ADA Curb Ramp New Construction Inspection Form (Perpendicular)

315th Ave

24952.54

PERPENDICULAR RAMP (PR)

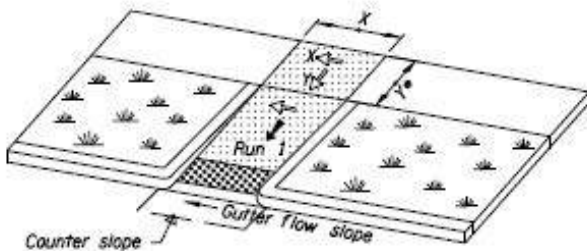
Cross Slope 1

2.3

☒

Counter Slope (+/-) *2

7.6

☒

Comments:

CRK c&g
